**Notes on NRC SER on ER-262  
Dated February 5, 2003  
Revision 7**

**Purpose**

The purpose of this document is to describe and clarify the inconsistencies that appear in WCAP-15689 REV 1 and are subsequently quoted in the SER dated January 28, 2003. It is provided at the request of the Steve Alexander in the Office of Inspection on January 29, 2003.

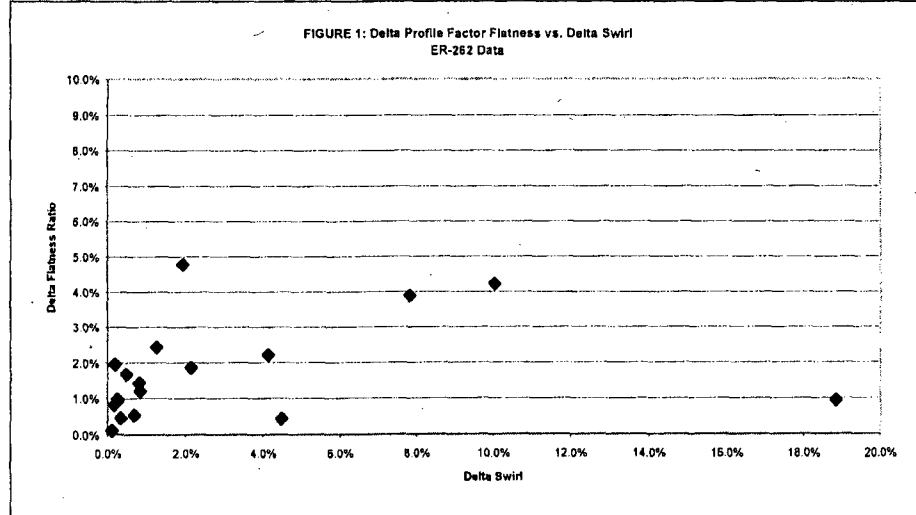
3. Evaluation
  - a. Caldon's evaluation does not conclude that all 18 pipe profiles changed only because of swirl as implied here. In fact the data provided indicates that profiles change without changes in swirl also. Figure 1 below plots delta Profile Flatness versus delta Swirl. Since there is a poor correlation it is clear that there are other causes, for example roughness, for profile shape change.

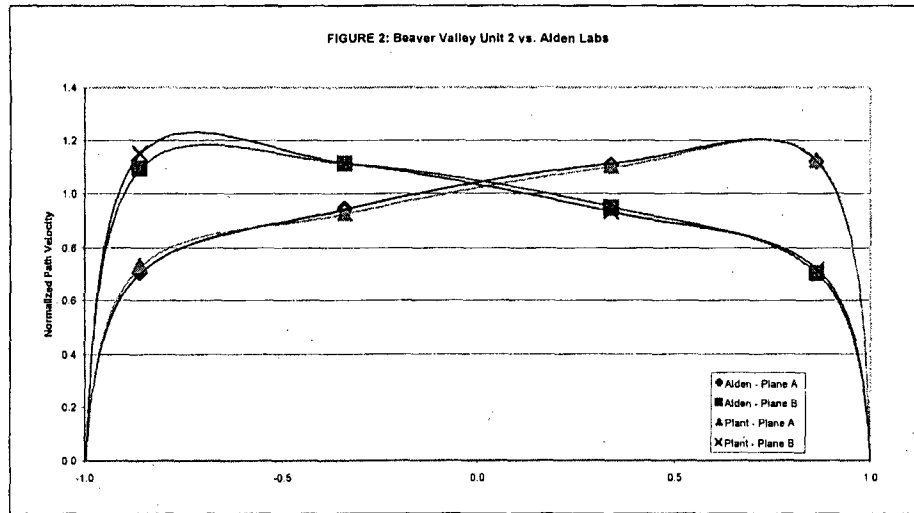
- c. The SER quotes WEC "**WEC determined that the conclusions presented in ER-262 regarding cross-correlation technology are not applicable to Crossflow and that the Crossflow technology is not subject to the specific technical issues associated with the Caldon transit time flowmeters.**" This statement seems to contradict other statements and data provided by WEC. ER-262 addresses sensitivity to velocity profiles. WEC published data (**Attachment 3**, Flomeko '98) provides quantitative data on sensitivity of the Crossflow technology to profile shape (2.5%). The ABB CENP Topical Report CENPD-397-NP states that Crossflow is sensitive to flow profile, and WCAP-15689 provides a quantitative sensitivity to swirl, another, but separate, profile effect (1%). The statement that the Crossflow meter is not subject to this technical issue (profile sensitivity) is inconsistent with the very basis for the profile factor determination as a function of Reynolds number, the statement in the ABB CENP Topical Report CENPD-397-NP, and the statement that test data shows a 1

percent change owing to swirl. See **Attachment 4**, "Sensitivities of Crossflow (and LEFM) External Systems to Profile Shape", for a detailed discussion of the Flomeko data.
